CITY OF
West Linn
PLANNING COMMISSION PUBLIC HEARING

FILE NO.: MISC-10-13

REQUEST: Extension of Water Resource Area permit (formerly called a Natural Drainageway Permit) and a Class II Variance for side yard setback and house height for a proposed house on a vacant lot west of 19740 Wildwood Drive (subject site has sometimes been referred to as 19738 Wildwood Drive)

STAFF REPORT PREPARED BY: Tom Soppe, Associate Planner

SITE AND DISTURBANCE LIMITS PLAN

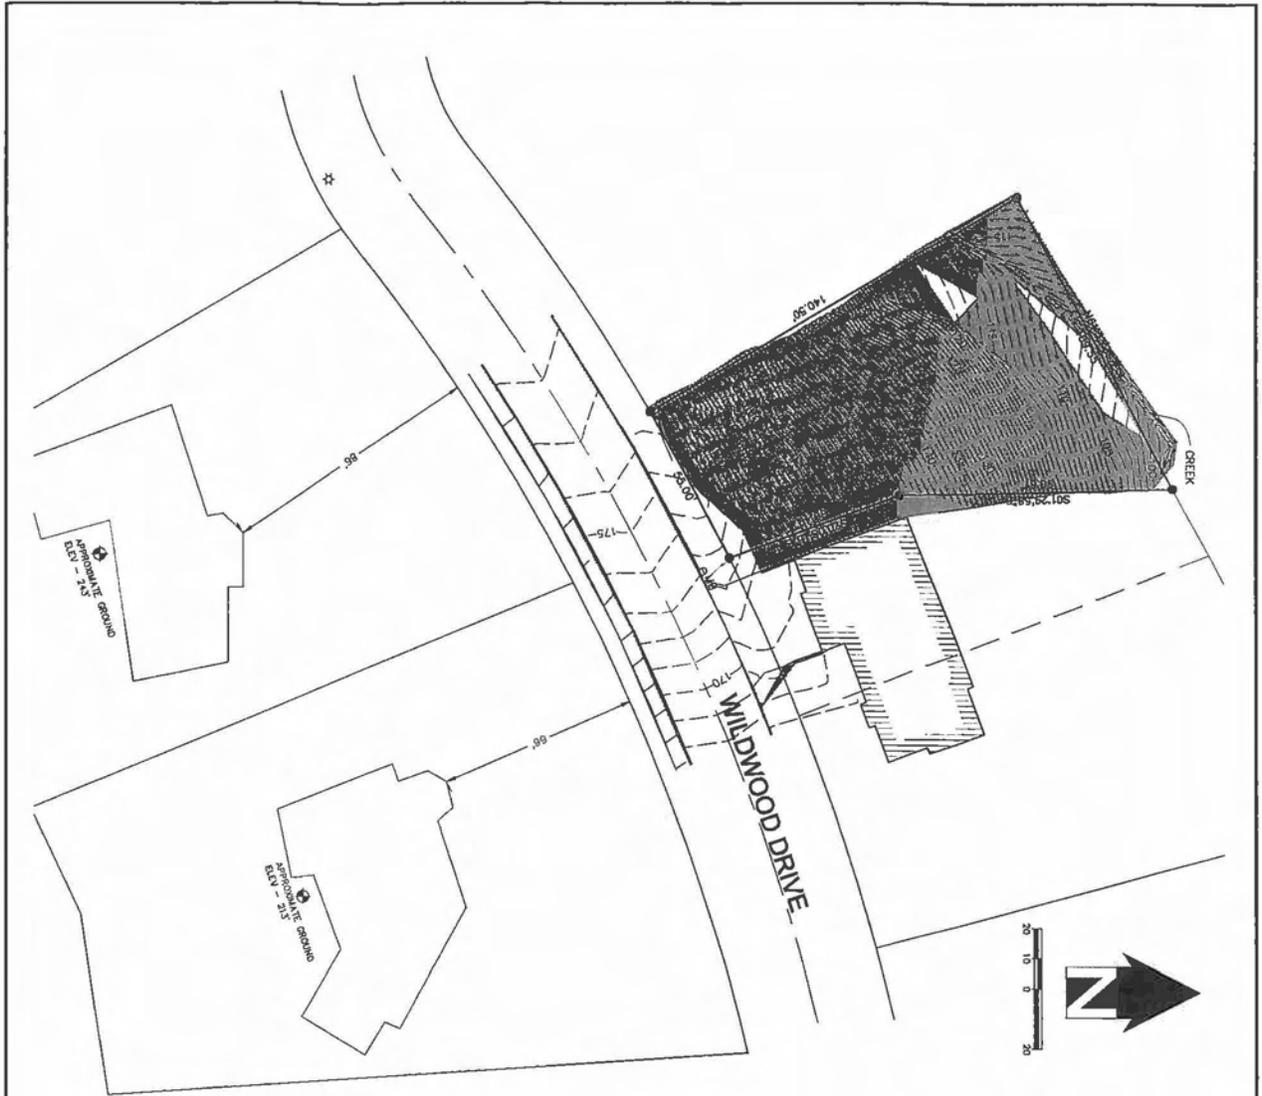
The easement on the existing conditions map is not large enough. You must propose and show one covering all areas of the lot to remain undeveloped.

Show creek and transition area on all site plans.

Show proposed stormwater facility.

Make it clear on the site plan whether the property is in Hidden Springs Ranch No. 6 or No. 9.

Show lots directly across the street and their structures, as they are abutting lots for the purposes of the effects of these variances.

Mention height variance on site plan.

Client should show street improvement or pledge to pay a fee in lieu. This can be taken care of during the building permit process since it is a new house. It is necessary now to show the location of the rain garden and new street light on the site plan.

I have attached a revised site plan that reflect this change and the 6-foot side yard setback we discussed earlier.
